UNITED STATES PATENT AND TRADEMARK OFFICE

10/655,854

Office Action Summary

DETAILED ACTION

FIG. 3

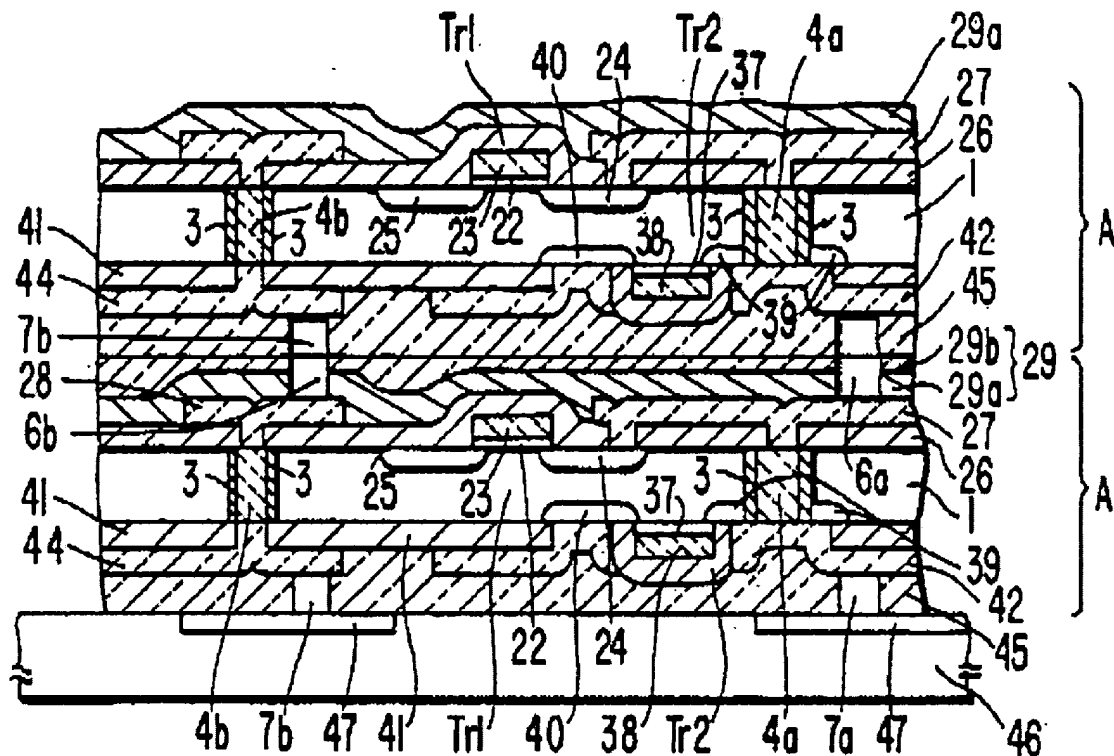
7. Regarding claim 17, Kato (e.g. fig. 3) show a multi layer integrated semiconductor structure, comprising:

A first device layer 1 including:

- First and second opposing surface
- A first semiconductor region (24, 25);
- A first dielectric material 29 disposed about the first doped semiconductor region, the dielectric material having at least a first via hole 6a;

A first conductive material 6a disposed in the via hole to provide a first conductive via having first and second opposing ends;

A second device layer 1 having first and second opposing surfaces including:

- At least a second doped semiconductor region (24, 25) and including a second via hole 4a; a second conductive material 4a disposed therein to provide a second conductive via having first and second ends;

A first interface "7a" (not labeled in the in figure 3 but located between 6a and 45) disposed between a first one of the first and second opposing surfaces of the first device layer and a first one of the first and second opposing surfaces of the second device layer such that the first interface secures together the first and second device layers and also electrically couples the first device layer to the second device layer wherein the conductive interface and the first and second conductive vias forms at least

a portion of an electrical communication path between the first device layer and the second device layer.

FIG. 2(a)

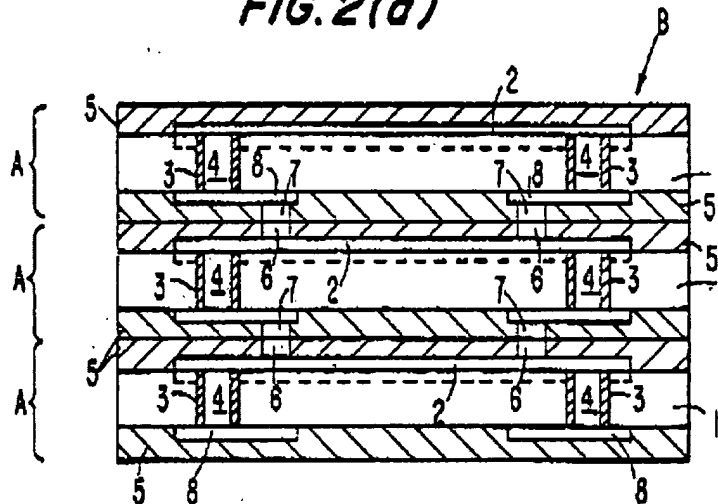
30. Regarding claim 41, Kato shows (e.g. figs. 2a and 3) shows a multi layer semiconductor structure, comprising: at least a first semiconductor structure 1 including a first plurality of conductive elements 4; at least a second semiconductor structure 1 including a second plurality of conductive elements 4; a first plurality of conductive bonding interface segments 7 disposed between the first and second semiconductor structures with each of the plurality of conductive bonding interface segments being in an electrical communication relationship with one or more of the conductive elements of the first semiconductor structure and one or more of the conductive elements of the second semiconductor structure; at least a third semiconductor structure 1 including a third plurality of conductive elements 4 and a second plurality of conductive bonding interface 7 disposed between the second and third semiconductor structures with each of the second plurality of conductive bonding interface segments being in electrical

communication relationship with one or more of the conductive elements of the second semiconductor structure and one or more of the conductive elements of the third semiconductor structure.
